SUBJECT Sketch Plat Walnut Grove 5th Addition

REVISED SKETCH PLAT
WALNUT GROVE 5TH ADDITION

Preliminary plat (revised)
SUBDIVISION REPORT

S/D No. 83-56 Name Walnut Grove 5th Addition
Date Application Rec'd. 6-21-83 Preliminary Approval _____
Scheduled S/D Meeting 1-5-84

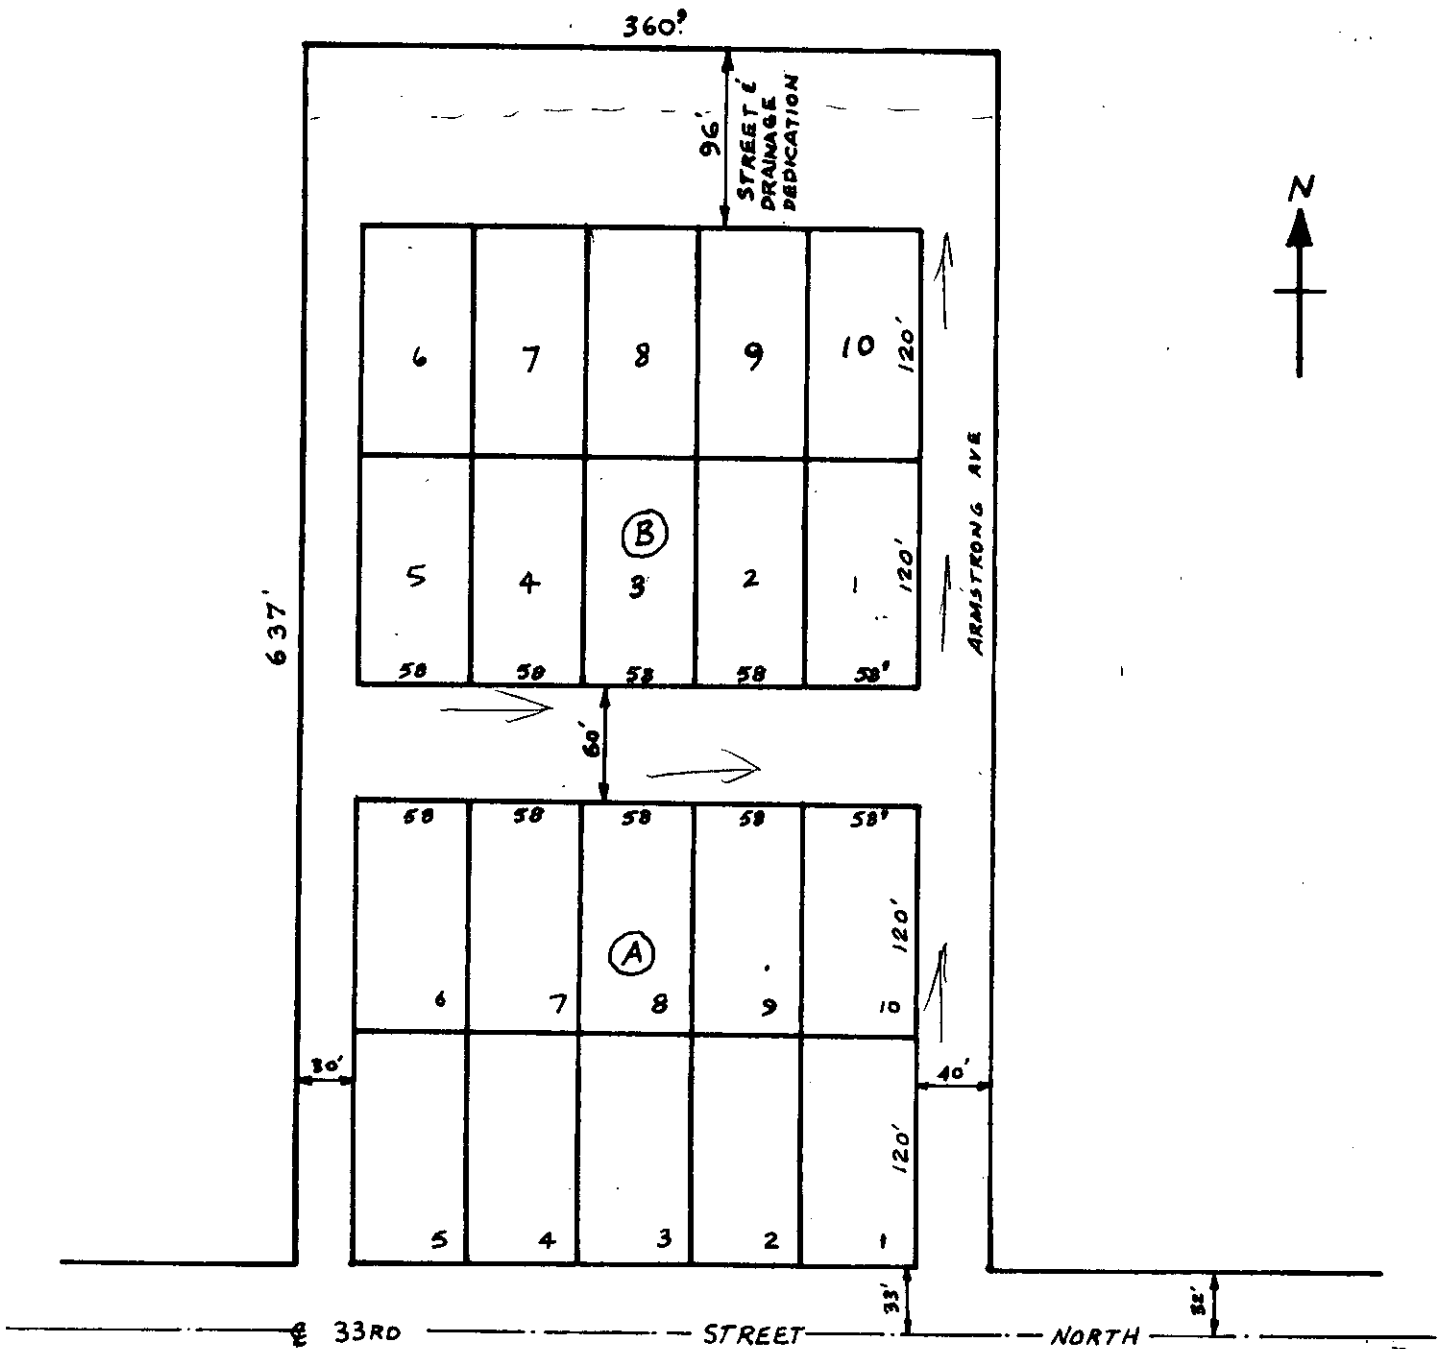
Comments on sketch plat of Walnut Grove 5th Addition:

1. The right of way identified above should be platted as drainage right-of-way.
2. If the property is platted in its current configuration, the channel should be relocated to the drainage right-of-way. This would require grading work on properties adjacent on the east and west.
3. If the channel is not relocated, restrictive covenants should be taken on Lots 5-12, inclusive.
4. It is suggested that only Lots 1-4 and 13-18 be platted at this time.

*34th St
& Arkansas
Right of Way*

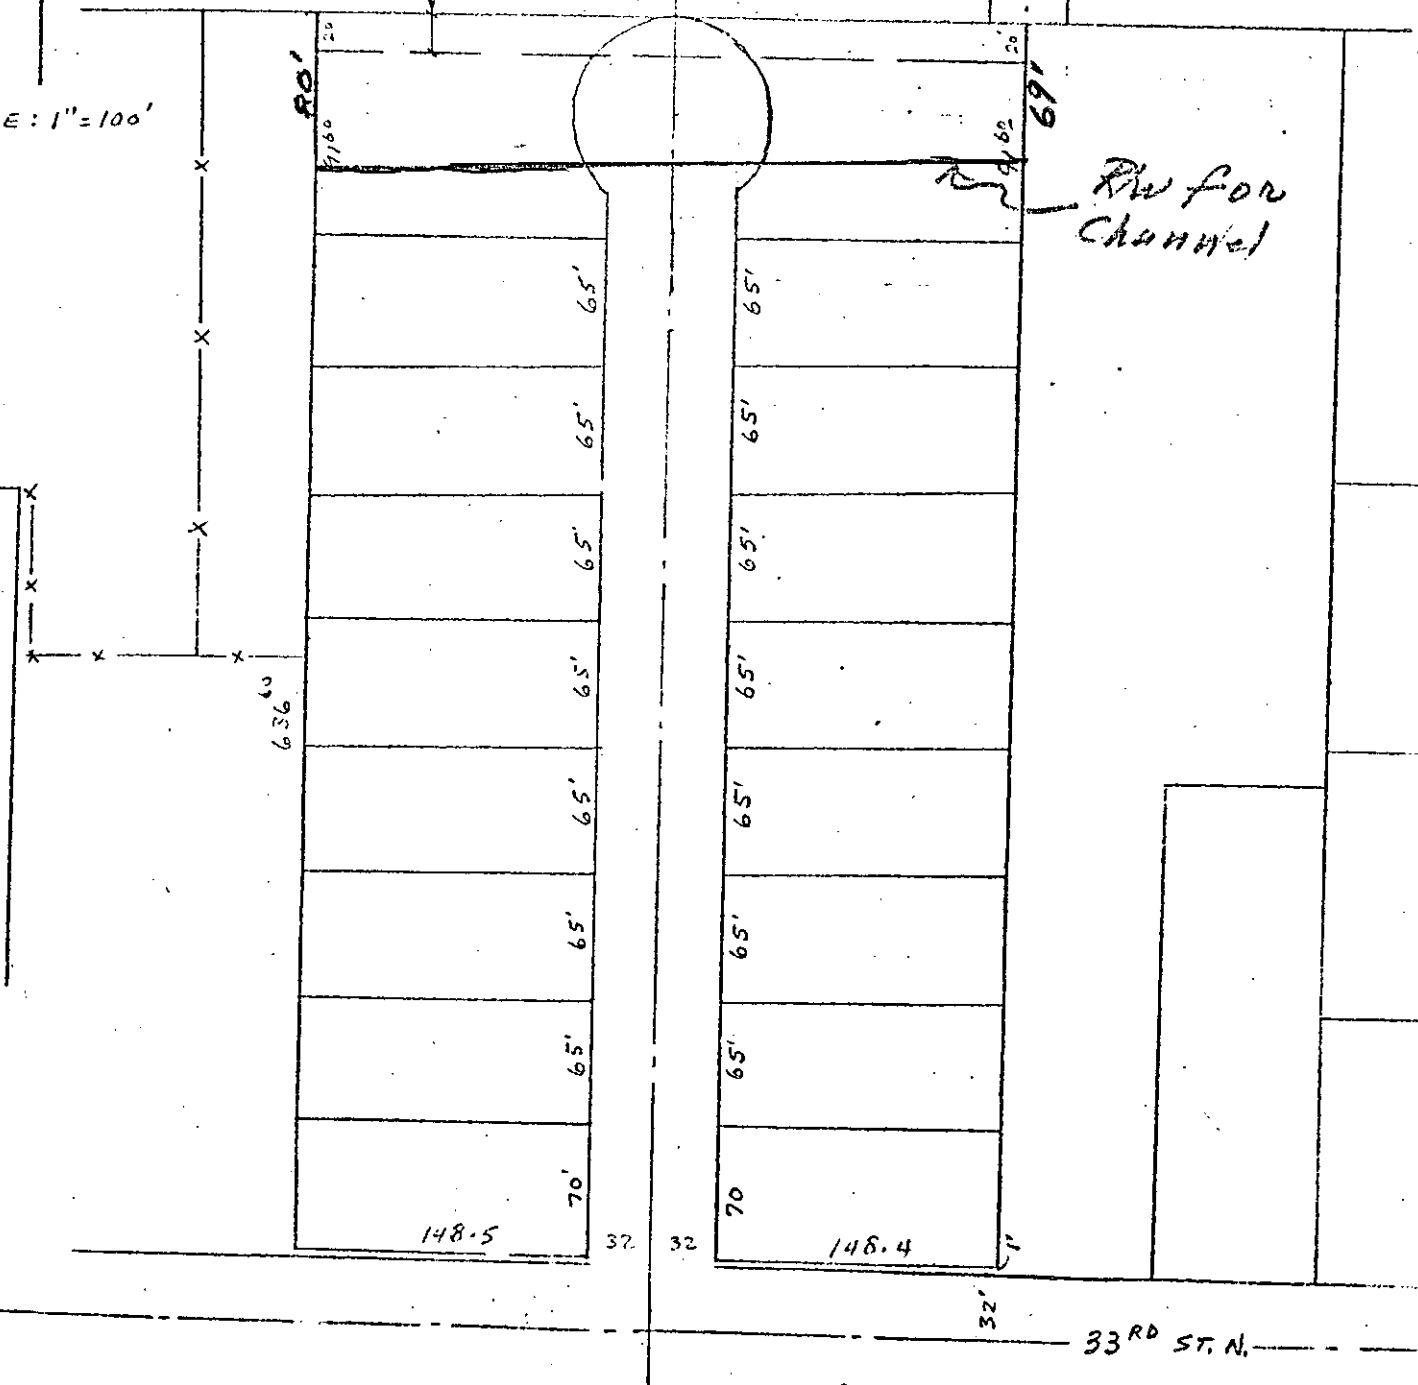
The right-of-way that was proposed for Project D-73 in 1982 is outlined in red. The right-of-way plans showed that most of the right-of-way would come from the property as shown in the sketch as opposed to the property to the north.
